UNITED STATES PATENT AND TRADEMARK OFFICE

APPLICATION NO.	FILING DATE	FIRST NAMED INVENTOR	ATTORNEY DOCKET NO.	CONFIRMATION NO.
09/750,073	12/29/2000	Joun Ho Lee	8733.376.00	6225

Office Action Summary	Application No. 09/750,073	Applicant(s) LEE ET AL.	
	Examiner Timothy L Rude	Art Unit 2871

DETAILED ACTION

Fig. 3

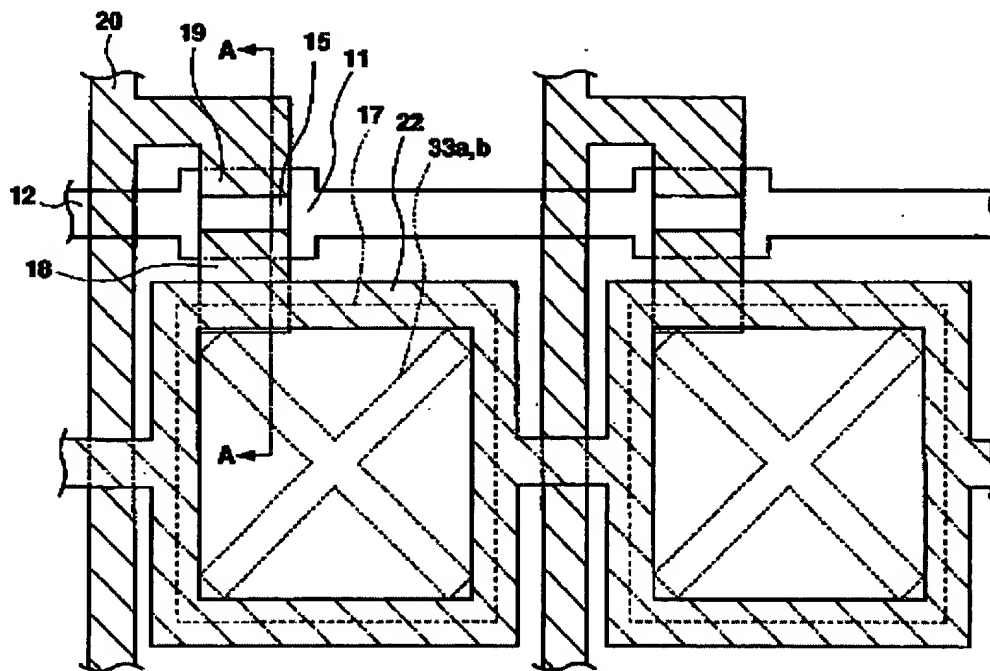
As to claims 1, 10, and 22, Koma discloses in Figures 3-7, (First embodiment, col. 5, line 21 through col. 7, line 67) a multi-domain liquid crystal display device comprising: a first substrate, 10, defined by a plurality of pixel regions; an orientation control electrode, 22, (Applicant's common auxiliary electrode) (col. 6, lines 5-8) around each pixel region on the first substrate; an orientation control window, 33a, filled with orientation film material, 34, (Applicant's dielectric structure) (col. 6, lines 28-34) (running from lower left to upper right) on a second substrate, 30, the dielectric structure dividing each pixel region into a plurality of domains (lower right domain from upper left domain); an additional structure (portion of 34 in 33a running from upper left to lower right) compensating electric field around a corner portion within each pixel region; and a liquid crystal layer, 41, between the first substrate and the second substrate.

Koma does not explicitly disclose at least one or more additional structures formed at an end portion of the dielectric structure within the pixel region.

As to claim 5, Koma discloses in Figures 3-7, (First embodiment, col. 5, line 21 through col. 7, line 67) the multi-domain liquid crystal display device of claim 1, wherein the orientation control electrode, 22, (Applicant’s common auxiliary electrode) is not formed with the gate electrode, 11, (Applicant’s gate lines) (on different layers per Figure 4, see also col. 5, lines 42-46).

As to claim 7, Koma discloses in Figures 3-7, (First embodiment, col. 5, line 21 through col. 7, line 67) the multi-domain liquid crystal display device of claim 1, wherein the dielectric structure includes a first orientation control window, 33a, filled with orientation film material, 34, (Applicant’s dielectric structure) (col. 6, lines 28-34) (running from lower left to upper right) on a second substrate, 30, and a second and third structure regions (portions of 34 in 33a running from middle to lower right and running from middle to upper left).
